ADDENDUM # 1

Bid 19C4, Urbana Elementary School Replacement – Construction Stage II

ADDENDUM NO. 1

RE: **URBANA ELEMENTARY SCHOOL REPLACEMENT**

E-1.2.1

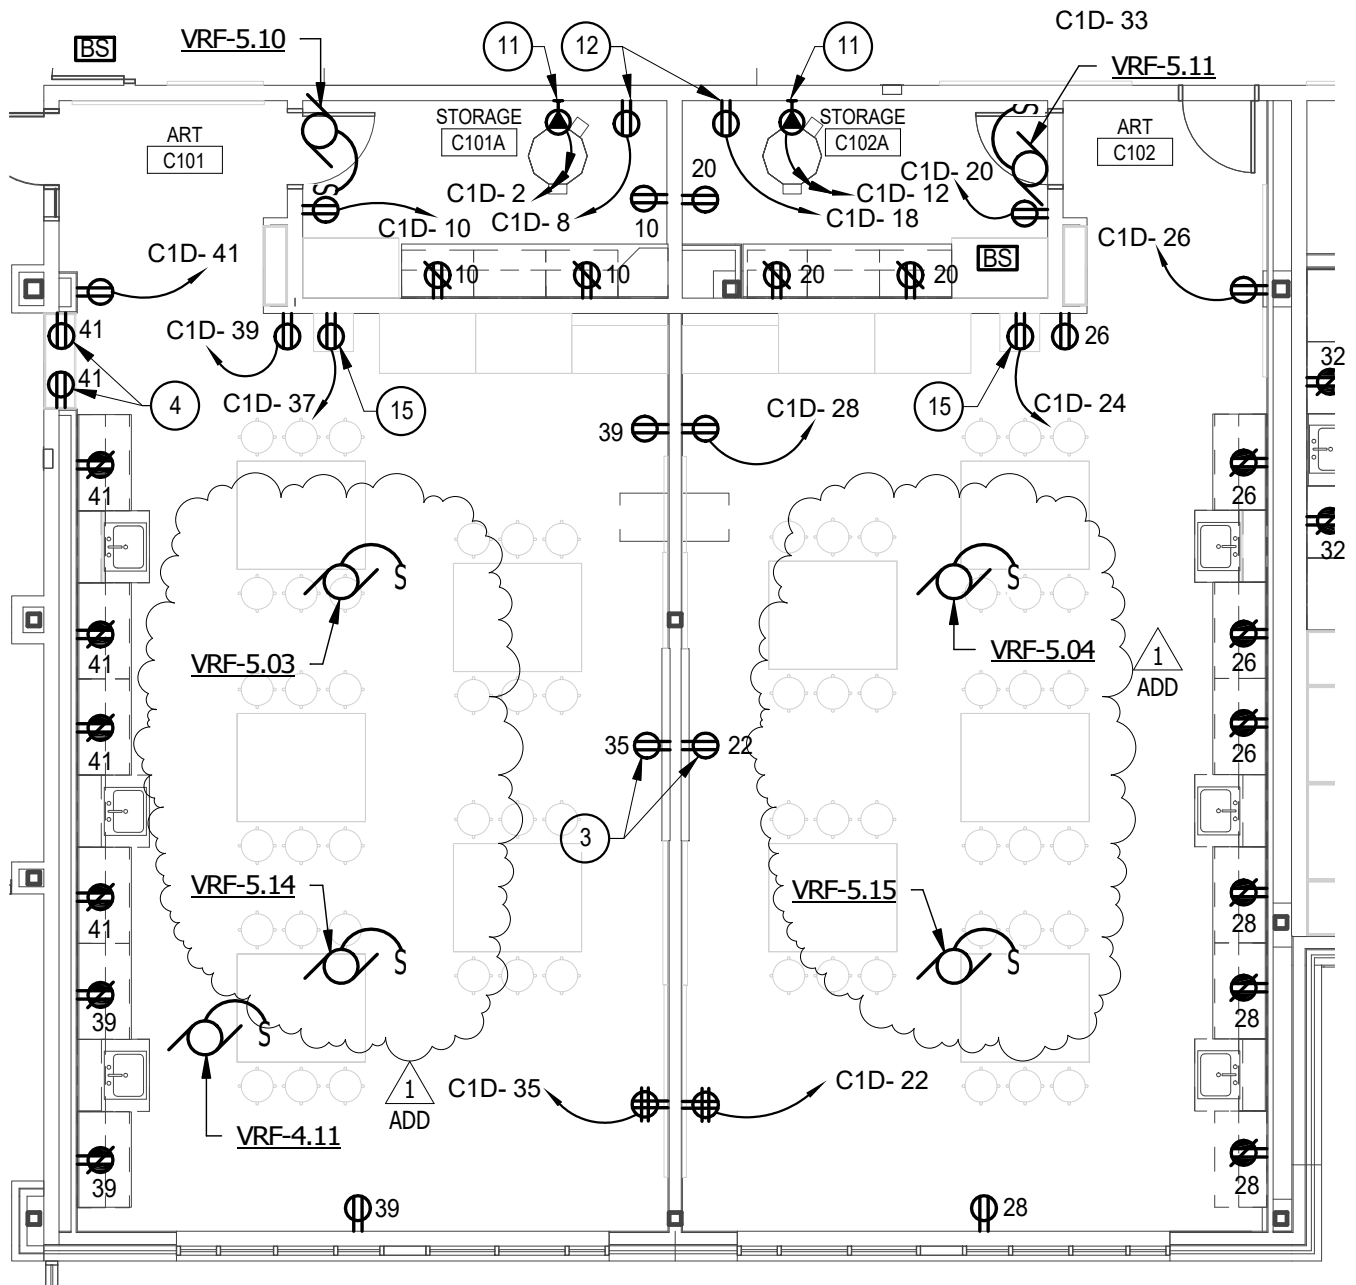
ITEM NO. E4:	<u>SHEET E-1.2</u> <u>PARTIAL FIRST FLOOR PLAN – AREA B - POWER</u>
ADD	Junction box for card reader at IDF B102A on circuit E2CB-3 with Drawing Note 8 reference. Refer to Sketch E-1.2.1 for additional information.

E-2.1.1

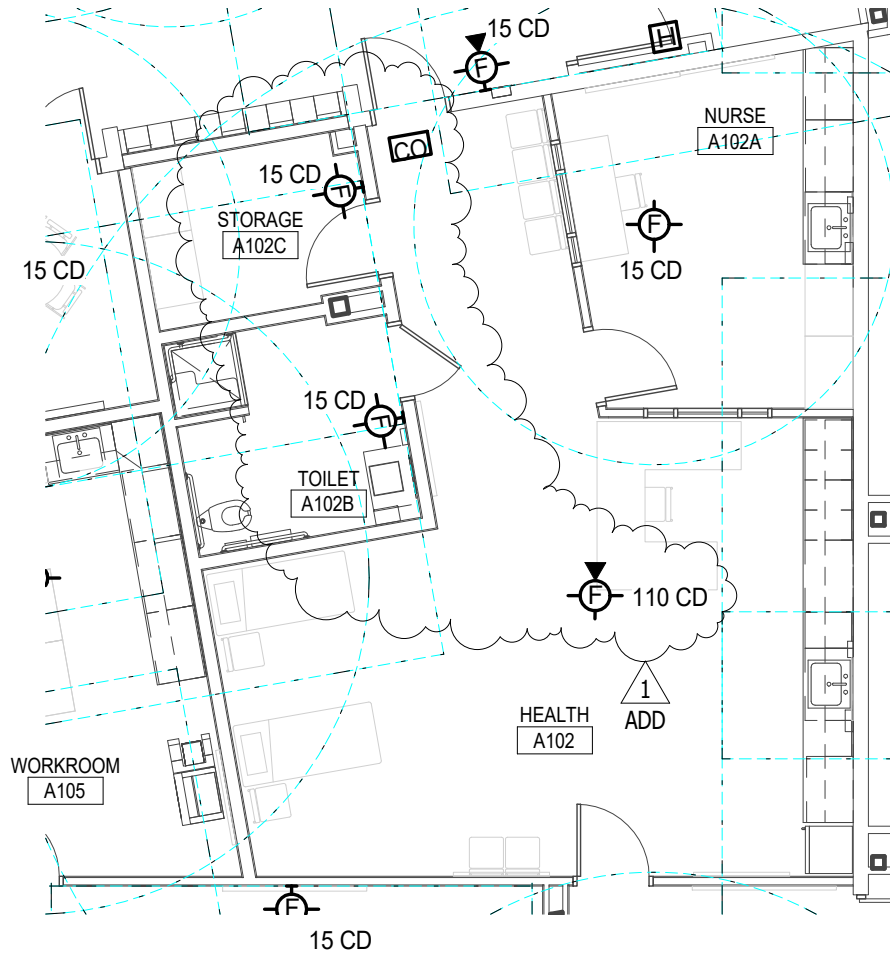
ITEM NO. E6:	<u>SHEET E-2.1</u> <u>PARTIAL FIRST FLOOR PLAN – AREA A – LIGHTING</u>
REVISE	Locations of lighting fixture Type A in Health A102, light switches in Toilet A102B and Storage A102C per architectural revisions. Refer to Sketch E-2.1.1 for additional information.
ADD	Drawing Note 10. Refer to Sketch E-2.1.1 for additional information.

ADD-1
E-3.1.1

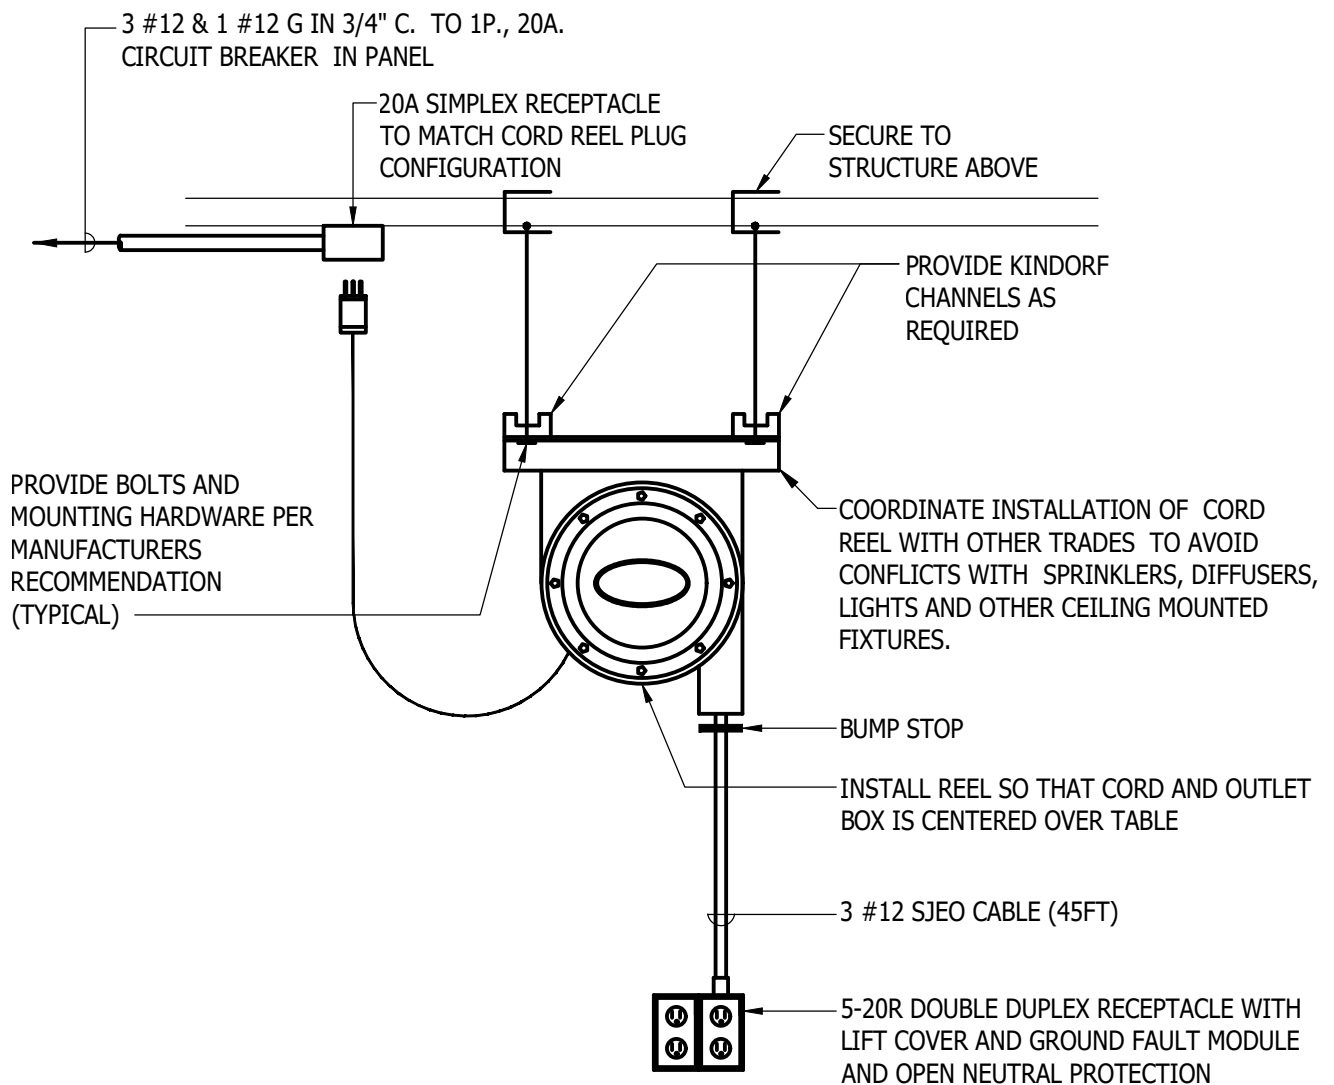
- ITEM NO. E7: SHEET E-3.1 PARTIAL FIRST FLOOR PLAN – AREA A – FIRE ALARM
REVISE Locations of Fire Alarm devices in Health A102, Toilet A102B and Storage A102C per architectural revisions. Refer to Sketch E-3.1.1 for additional information.
- ITEM NO. E8: SHEET E-6.3 LIGHTING CONTROL SCHEDULES AND RISER DIAGRAM
ADD Power Cord Reel Detail. Refer to Sketch E-6.3.1 for additional information.
- ITEM NO. E9: SHEET E-7.1 PANEL SCHEDULES
ADD VRF-5.14 and VRF-5.15 to circuit R1C-29 Description.
- ITEM NO. E10: SHEET E-8.1 MECHANICAL EQUIPMENT CONNECTION SCHEDULE
ADD VRF-5.14, VRF-5.15 and Note 16 to Schedule. Refer to Sketch E-8.1.1 for additional information.

27) RADON VENT PIPING DETAIL

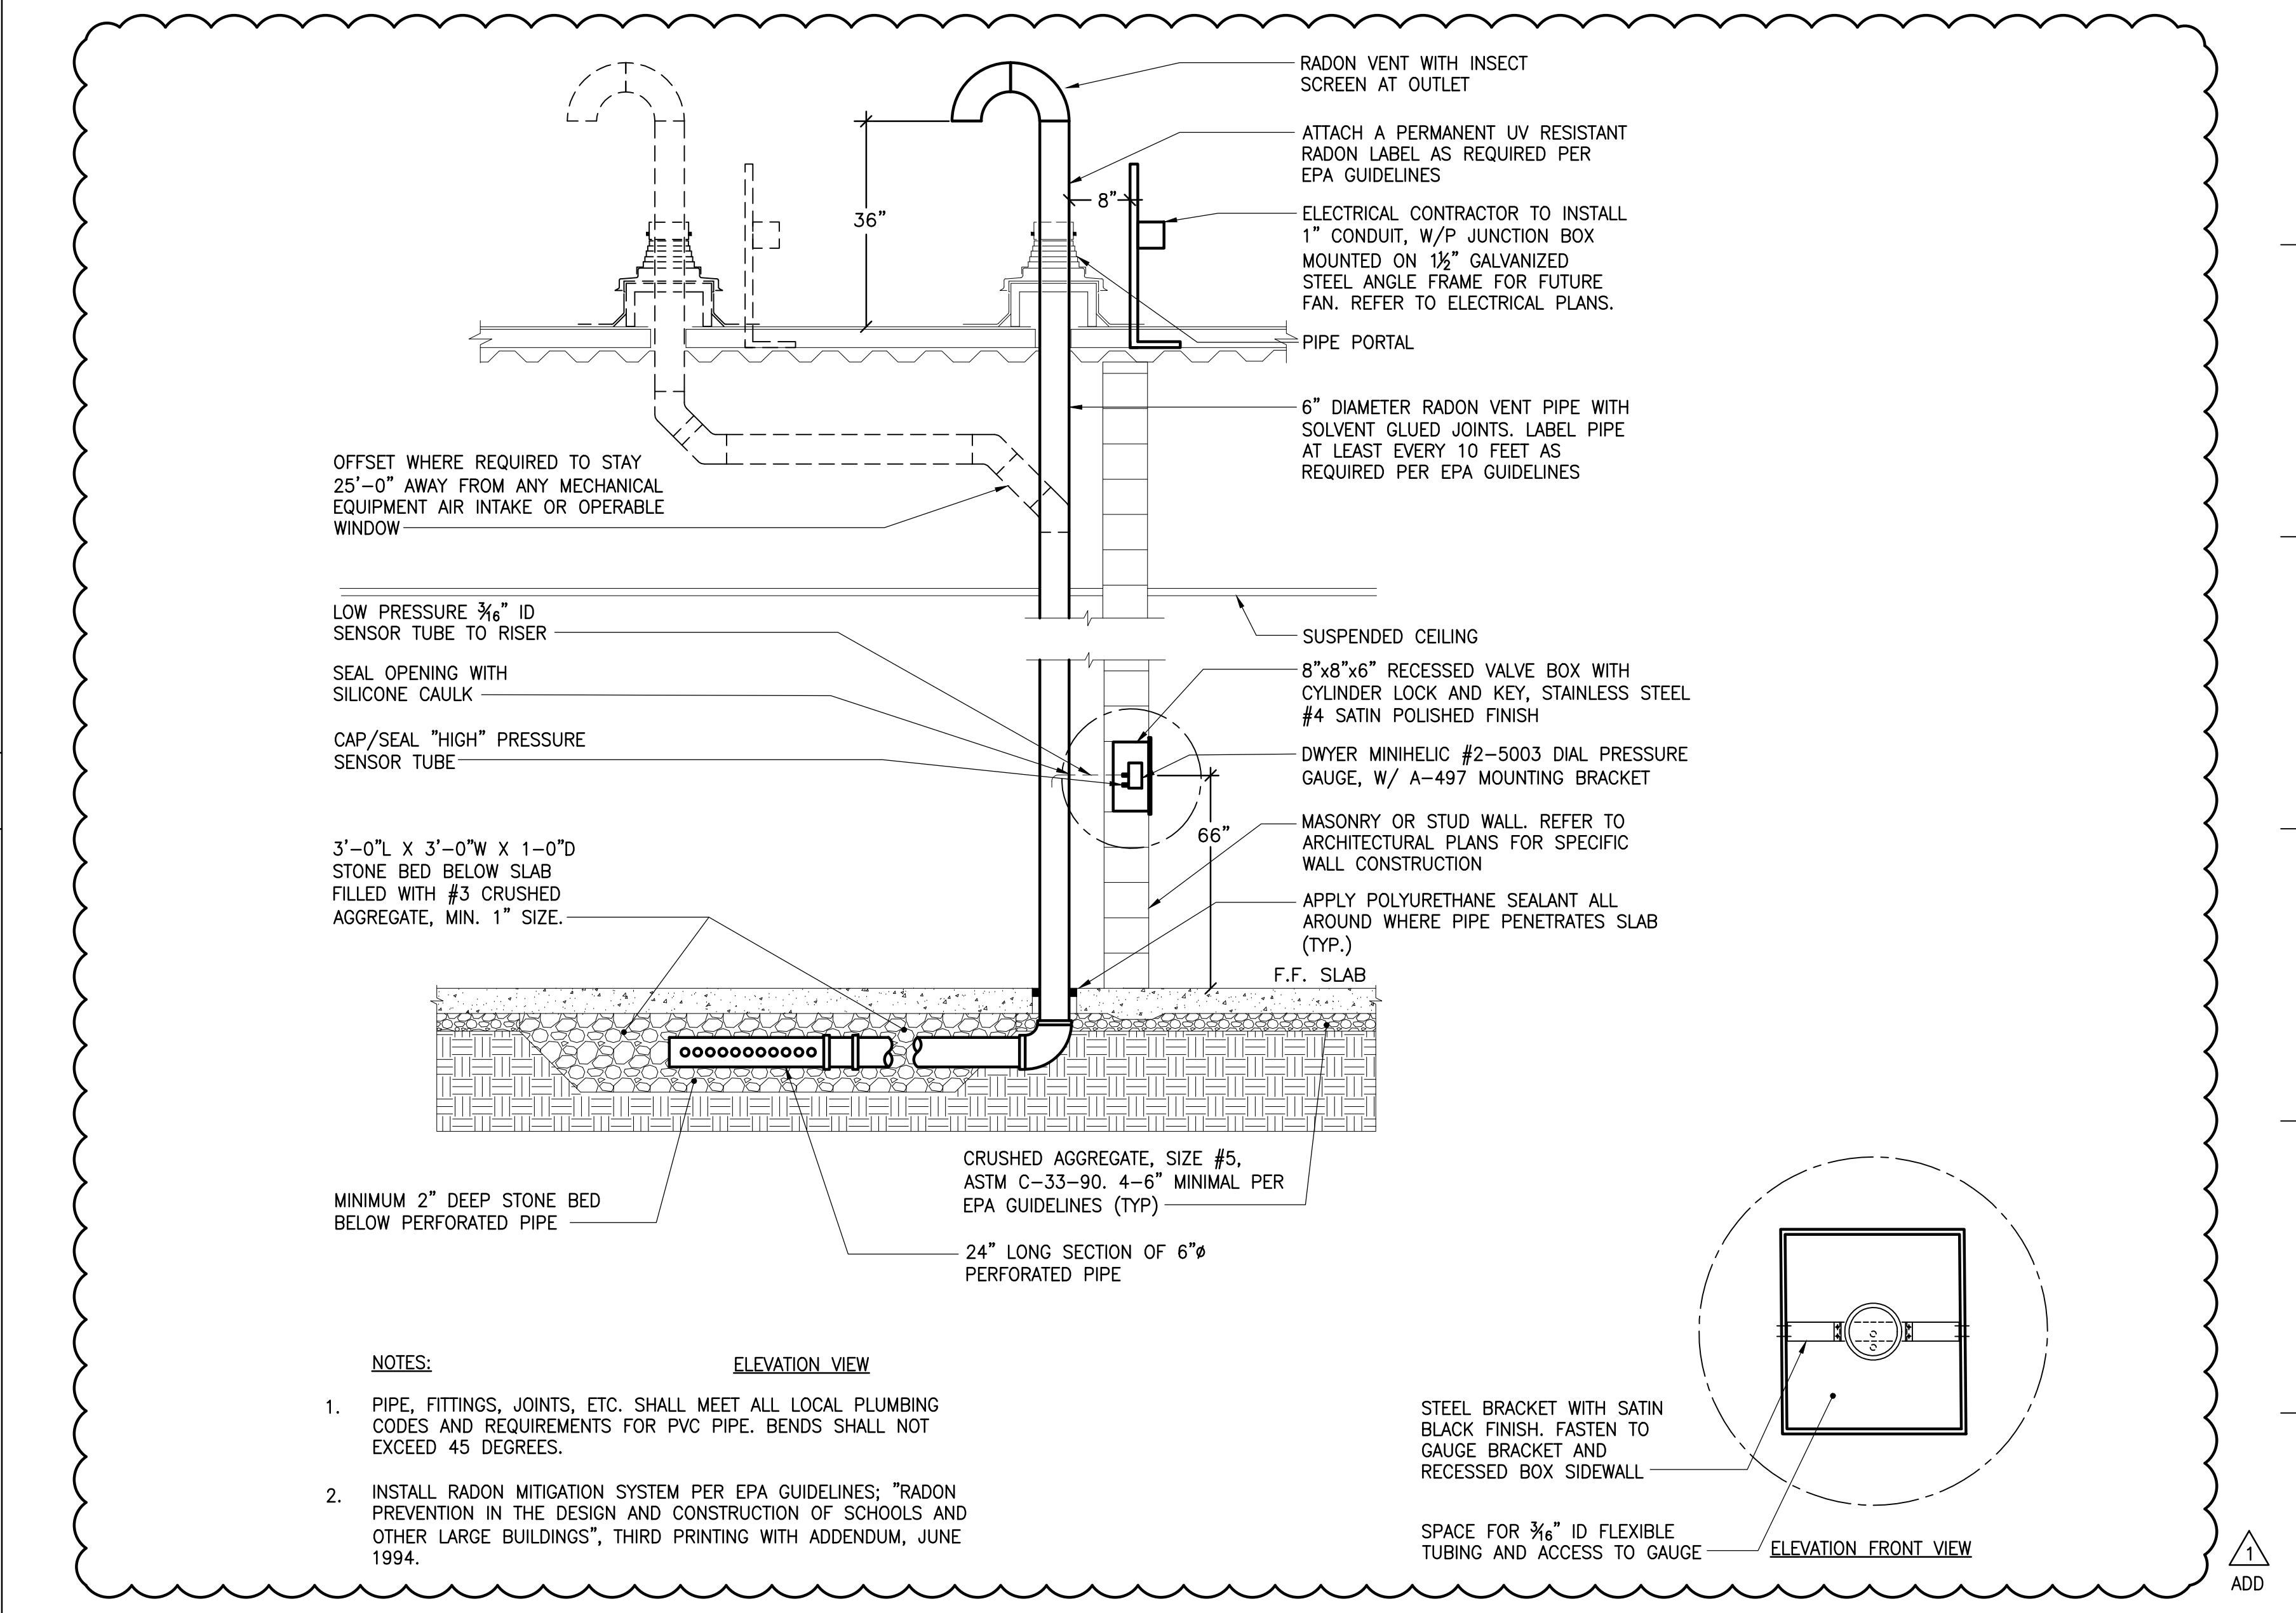
REVISE	Art C101 VRFC CD piping. Refer to sketch SKP-2.3.1.
REVISE	Art C102 VRFC CD piping. Refer to sketch SKP-2.3.1.
ADD	Art C101 VRFC and associated CD piping. Refer to sketch SKP-2.3.1.
ADD	Art C102 VRFC and associated CD piping. Refer to sketch SKP-2.3.1.
ITEM NO. P3:	<u>SHEET P-2.4</u> <u>PARTIAL FIRST FLOOR PLAN – AREA C2</u>
REVISE	Toilet C124 Washfountain P3D revise to P3C.
REVISE	Toilet C125 Washfountain P3D revise to P3C.
ITEM NO. P4:	<u>SHEET P-7.2</u> <u>PLUMBING EQUIPMENT DETAILS</u>
SUBSTITUTE	Entire sheet with sheet included with this addendum. Revisions include the following:
REVISE	Detail 27 – RADON VENT PIPING DETAIL
